ADEQUACY OF STATION ELECTRIC DISTRIBUTION SYSTEM
VOLTAGES, FORT ST. VRAIN NUCLEAR GENERATING STATION

Report No. EGG-EA-5914

TAC No. 46503
Docket No. 50-267

This EG&G Idaho, Inc., report reviews the capacity and the capability of the onsite distribution system at the Fort St. Vrain station, in conjunction with the offsite power sources, to automatically start and continuously operate all required safety loads.

Figure 1. Fort St. Vrain unit single line diagram.

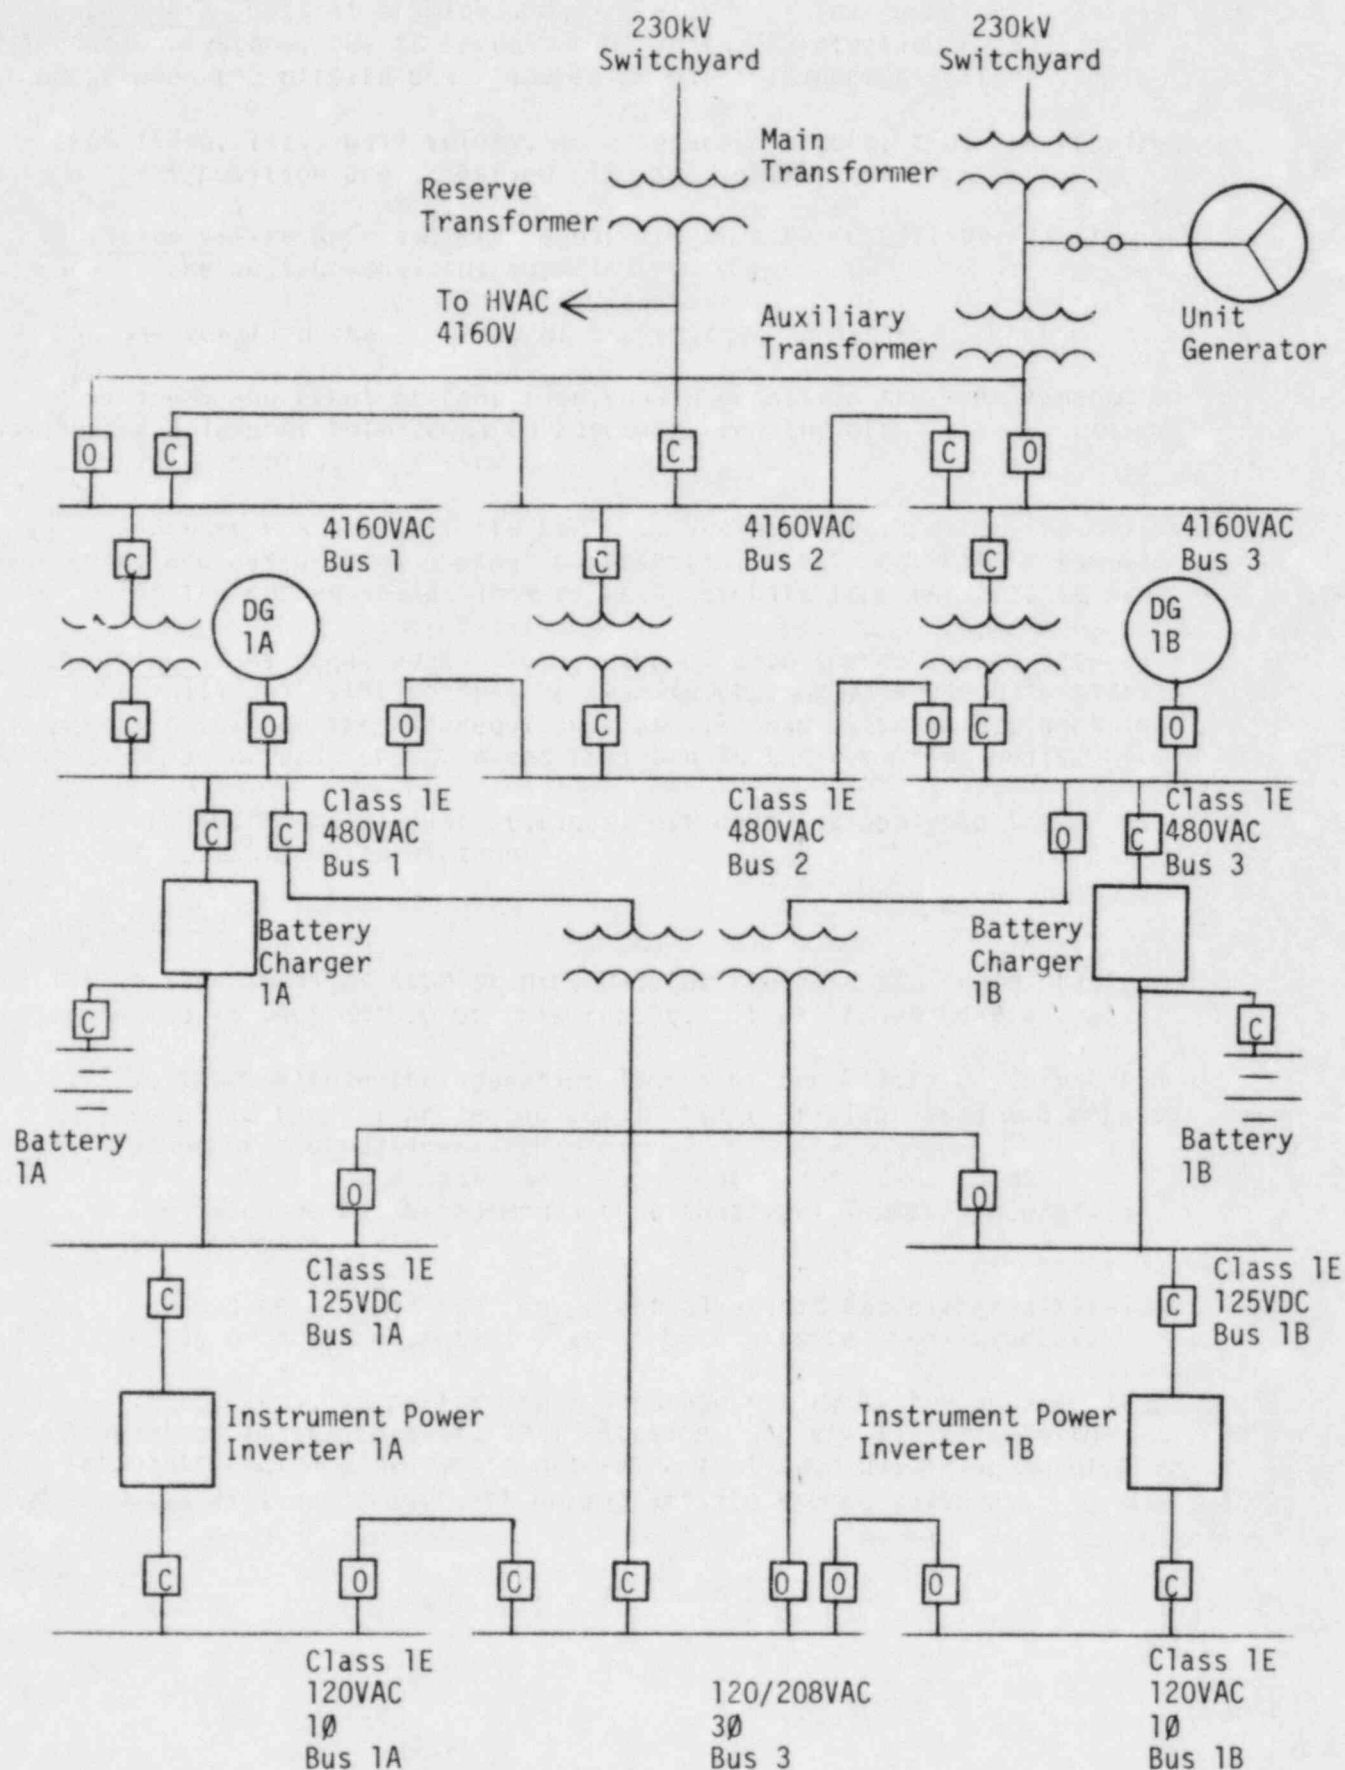
Figure 1 is a simplified sketch of the unit single-line diagram of the Fort St. Vrain electrical distribution system. It shows that the 480V Class 1E buses 1, 2 and 3 are supplied power by independent transformers from 4160V buses 1, 2 and 3 respectively. These three buses are interconnected to a single reserve auxiliary transformer (RAT) which is the preferred source of offsite power. The alternate source of offsite power is via the unit auxiliary transformer, with the unit generator links removed.

120V Class 1E buses 1A and 1B are normally supplied power by DC bus powered inverters. Should an inverter be out of service, a connection to 120V bus 3 is available as an alternate source.
